Quality Bulletin

Service Action SP1080: PS3 Tailgate Leakage Model Year 2025 Polestar 3

SP1080

QB Instruction VCC-534128-3

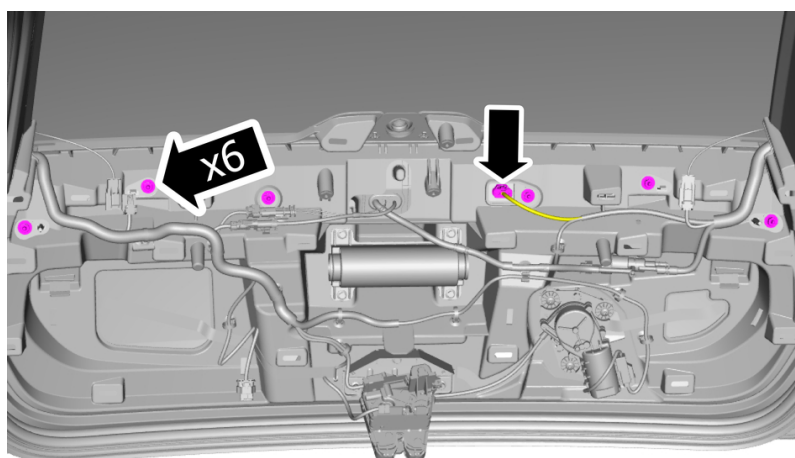
The concern with the tailgate is that 5 holes are drilled and not resealed which may cause water intrusion into the tailgate.

The holes are in the embosses and can be covered by a “tape” or similar in a first attempt to stop the water.

Orientation view**Use:** Adhesive gun

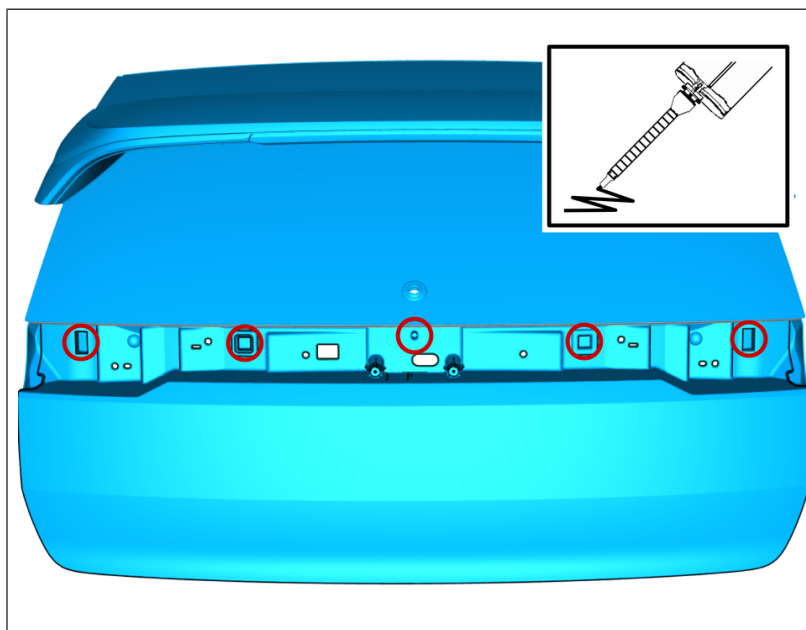
Seal the hole.
